Pedestrian and Cycling Improvements to Ferry Lane – Briefing Note

This note provides further information in response to comments regarding proposals for pedestrian and cycle network improvements on Ferry Lane, to provide improved access to Tottenham Hale station from the east following its upgrade. These proposals are the subject of a planning application to London Borough of Haringey (LB Haringey) – Planning Reference: HGY/2023/3078.

Figure 2- Revised Cross-Section Showing changes in lane widths.

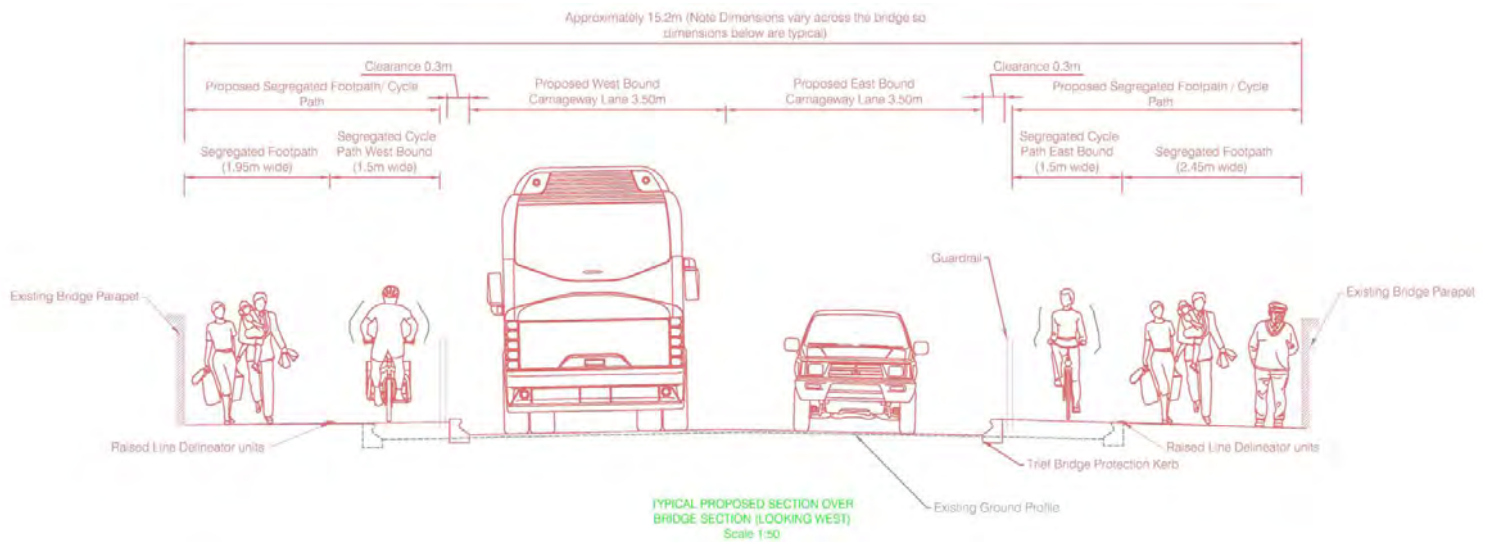
Some highlighted that the scheme, as submitted, results in a reduction of space for pedestrians on the south side and are not supportive of this change.

Our analysis demonstrates that it is possible to achieve scores equivalent a B+ or higher on both footways, following some further tweaking to the design. Including changes in the placement of the metal barriers by adding width back to the southern footway, which some consultees have requested. This will enable both footways to accommodate the predicted footfall, based on our pedestrian flow surveys. Figure 2 below shows the revised lane widths that would deliver pedestrian comfort levels equivalent of B+

We have listened to people's concerns about the width of the southern footway, and we have made adjustments so that footways on both sides will conform with acceptable pedestrian comfort for their predicted numbers of pedestrians (see section 4 above). Shared use routes for pedestrians and cyclists are a common feature in streetscape design and are implemented across London. Good design can help influence safe use, such as maintaining sufficient lane widths and maintaining a high tonal contrast between the surfaces of the two lanes. This scheme increases the cycle lane widths to the recommended minimum. As both pedestrians and cycles have sufficient space should neither pedestrian nor cycles should feel the need to encroach into the others space.

Figure 4 Diagram demonstrating the minimum clear widths required for different pedestrians (from London Cycling Design Standards guidance)

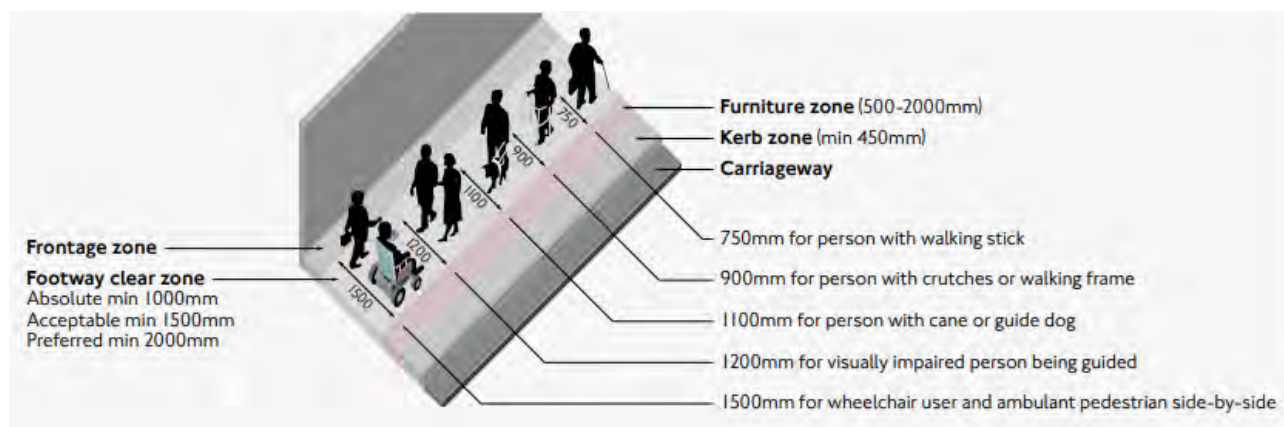
Some respondents have stated that the existing footways are not suitable for those with wheelchairs, or pushchairs, due to the levels of crowding experienced. This is likely not helped by the fact that the current Pedestrian Comfort levels are substandard. However, following some further tweaks to the distribution of space across footways (see response in 3.2). The scheme now delivers clear widths (i.e., paths that are unobstructed by signs, lamps, furniture) that will better accommodate for such users. Guidance states that a wheelchair user, accompanied by an ambulant pedestrian require a clear width of 1.5m (see figure 4 below) and this scheme delivers that. As the detailed design develops, engagement will be undertaken with specialist groups. Details of surface treatments and tactile paving will continue during this process.
